Urgent Field Safety Notice

New warning in Instructions for Use for Ambu® aView™ 2 Advance

Ambu A/S - Single Registration (SRN): DK-MF-000001437

VESA interface for mounting on medical carts

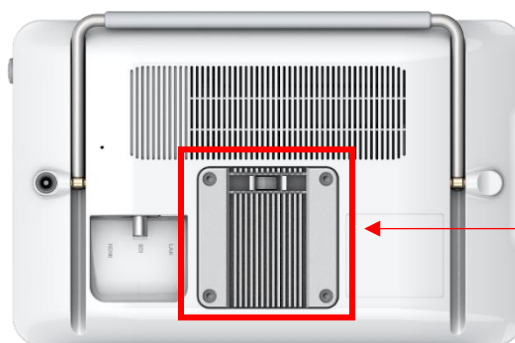
Ambu has received information on two incidents where Ambu® aView™ 2 Advance caught fire when mounted on the VESA holder of the aCart™ Compact, due to the screws used entering the lithium-ion battery of the device. No patients or staff members were harmed during the incidents.

Upon conducting a comprehensive investigation, we have identified the root cause of these incidents. The fire hazard was a direct consequence of a battery short-circuit, which, in turn, was triggered by the use of excessively long screws to secure the device on the VESA holder. The longer screw lengths inadvertently penetrated the lithium-ion battery, leading to the fire hazard.

Since VESA option is available in the product design, we want to inform our customers of the risk of penetrating the lithium-ion battery when using too long screws for mounting. At the same time, we would like to inform our customers on how to securely fasten the Ambu® aView™ 2 Advance. In case your Ambu® aView™ 2 Advance is placed on a table or mounted on an IV pole as recommended practice there is no risk of penetrating the battery and associated fire hazards.

Use only M4 screws with the length of 14 – 16 mm when mounting Ambu aView 2 Advance on a VESA interface. Using longer screw lengths will penetrate the lithium-ion battery and result in a fire hazard and battery leakage which can cause severe burns, smoke inhalation and skin irritation. Using shorter screw lengths could result in unsecure device fastening.
